#2019-113
Raising Canes – Preliminary and Final PUD
Project Review for Planning and Zoning Commission

Meeting Date:	May 6, 2020 public meeting and May 20, 2020 public hearing
Request:	Preliminary and Final Planned Unit Development for a new 3,316 square-foot limited service restaurant.
Location:	5417 Northwest Highway
Acreage:	Approximately 1.15 acres
Existing Zoning:	B-2 PUD General Commercial Planned Unit Development
Surrounding Properties:	North: B-2 PUD General Commercial South: M Manufacturing (Three Oaks Recreation Area) East: B-2 PUD General Commercial West: B-2 PUD General Commercial
Staff Contact:	Elizabeth Maxwell (815.356.3615)

LANDSCAPE PLAN

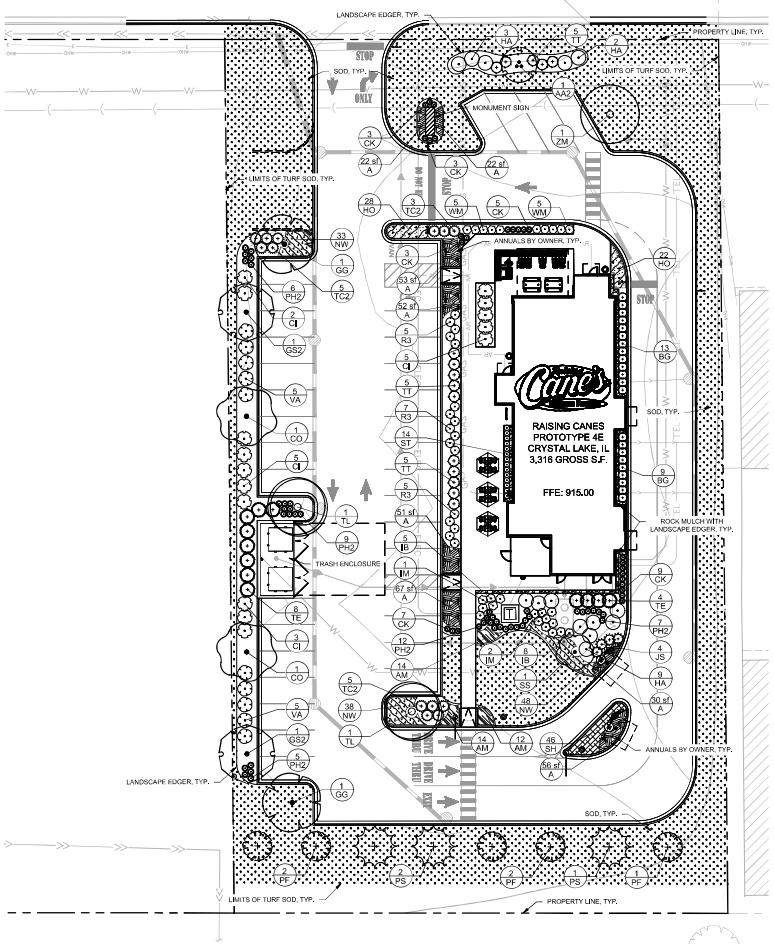
- Landscaping parking lot screening strip is provided along the western perimeter of the site.
- Between the building and the parking area is a generous landscape strip containing, knockout rose bushes, dogwood, spirea and yews.
- Planted along the building are small boxwood bushes for the foundation base landscaping.
- Within the 20-foot area reserved for the future boardwalk are some Pyramid Pines and White Pines.
- Screening is provided around the trash enclosure and the transformer.

3. Landscape Plan
   A. Add a tree and 5 shrubs to the landscape end island just to the east of the monument sign.
   B. Add some landscape shrubs along the curve of the drive-through to screen any headlights exiting the drive-through to Route 14.

EXTERIOR ELEVATIONS

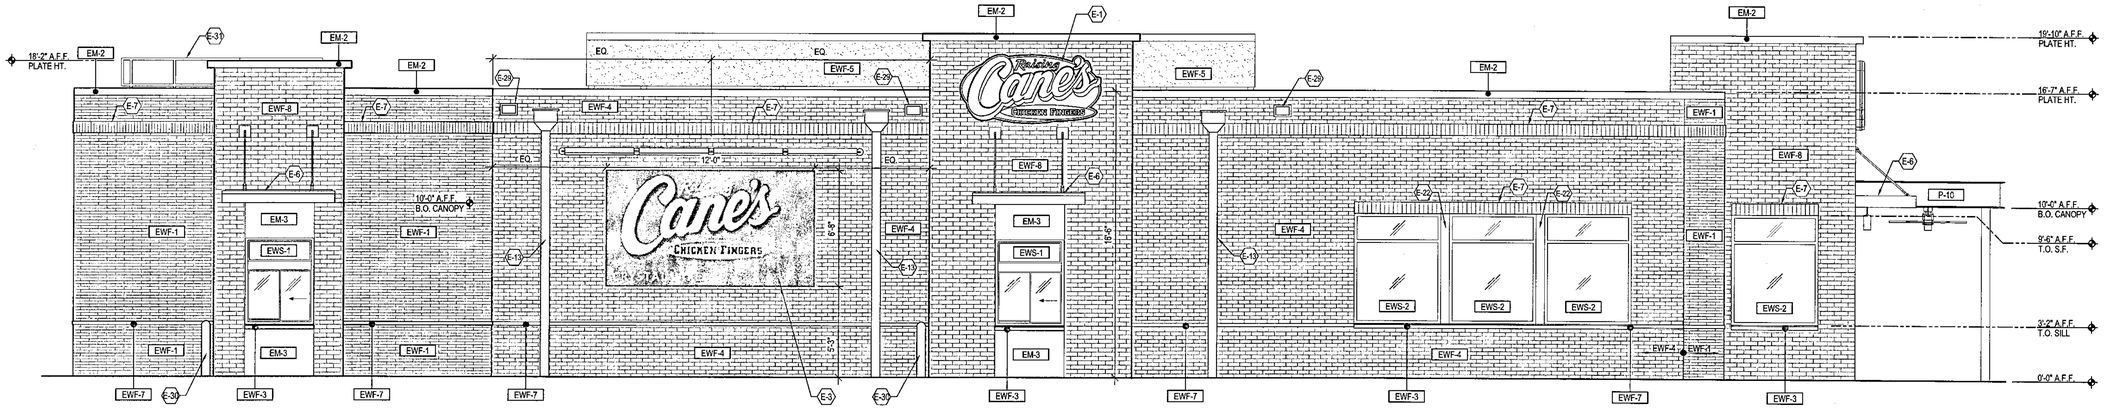
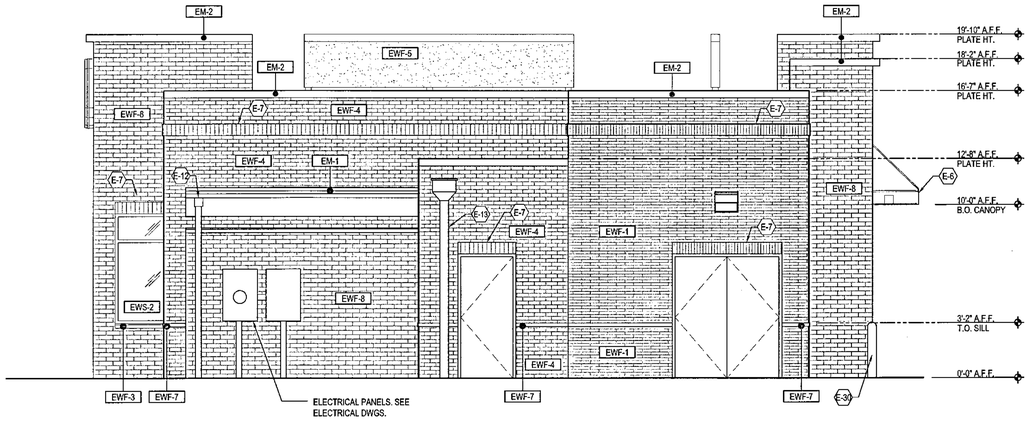
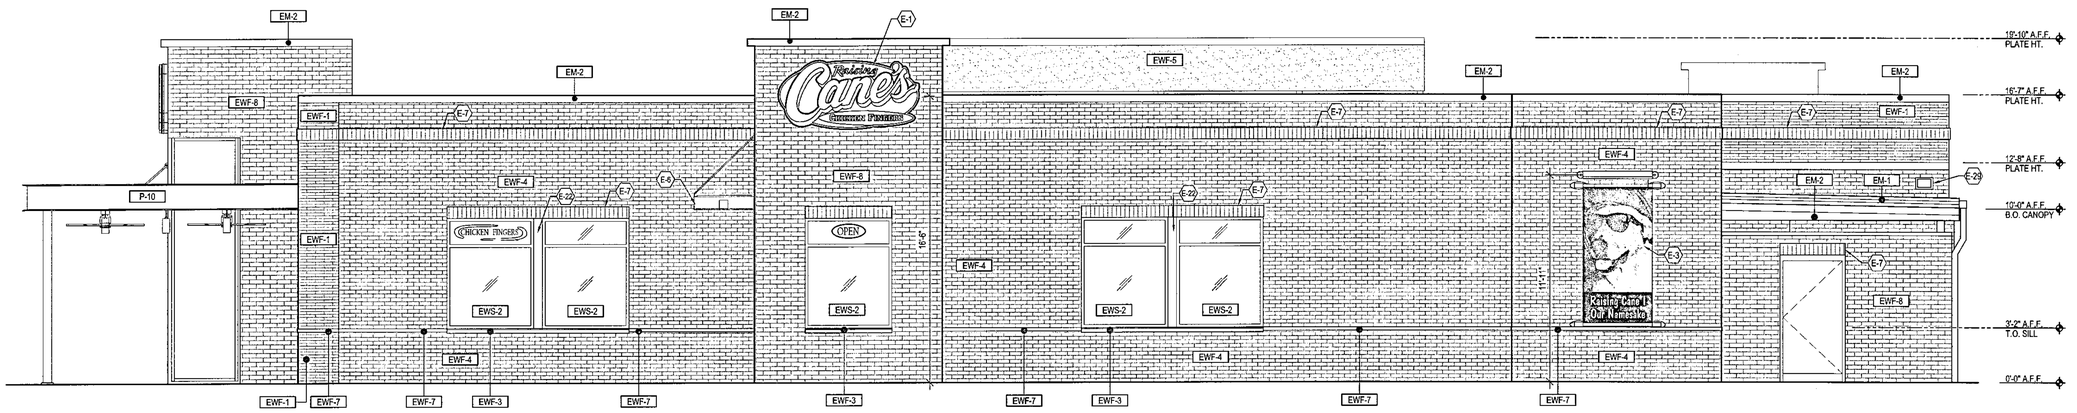
- Banding of soldier course brick defines the top portion of the façade and is found above the doors and windows.
- Dark awnings, metal framed windows and doors and metal top cap provide additional accents around the building.
- Staff has reviewed the elevations based on the criteria listed in the Design Standards. The project meets 8 of the 10 criteria with one being no and one being not applicable. Six of 10 are required to be considered meeting the design standards for architecture.
- Illumination is not permitted to outline portions of the building, the cove lighting shall be removed and a condition of approval has been added.

4. Elevations
   A. Remove all cove lighting or illuminated banding around the building.
   B. Eliminate all flags mounted on the parapets.
